Western Star  
Service Bulletin

## General Information

## Radiator Mount Replacement

**Fig. 1, Crack in Coolant Tube**

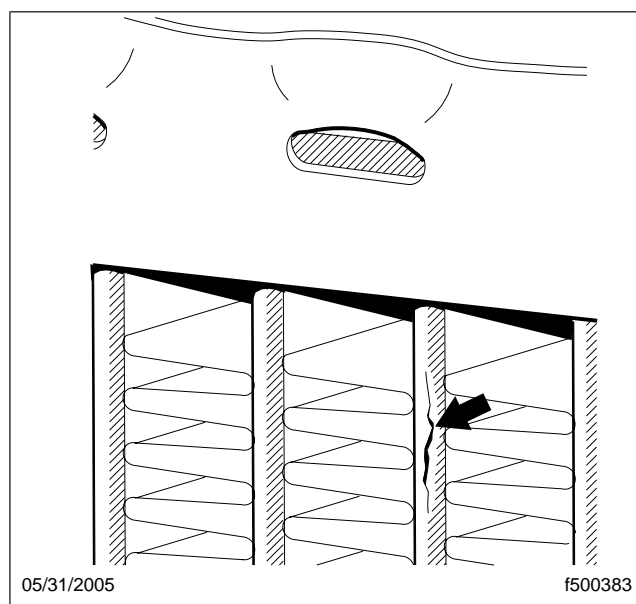
Some EPA10 compliant Western Star 4900 vehicles equipped with 1700 sq in aluminum radiators, manufactured March 2010 and later, with specific combination of engine operating parameters, may have radiator failures resulting in a coolant leak due to a crack in the coolant tube. See [Fig. 1](#). Leaks in other places (at the end tank, header, fittings, or any place other than the coolant tubes) do not apply for this bulletin. If leaks occur in the coolant tubes, Western Star recommends a radiator update to an isolated engine-mounted radiator. Isolated engine-mounted radiators were production installed in 4900 models beginning in August, 2012. This procedure is to replace a standard 1700 sq in aluminum engine-mounted radiator with an isolated 1700 sq in aluminum engine-mounted radiator.
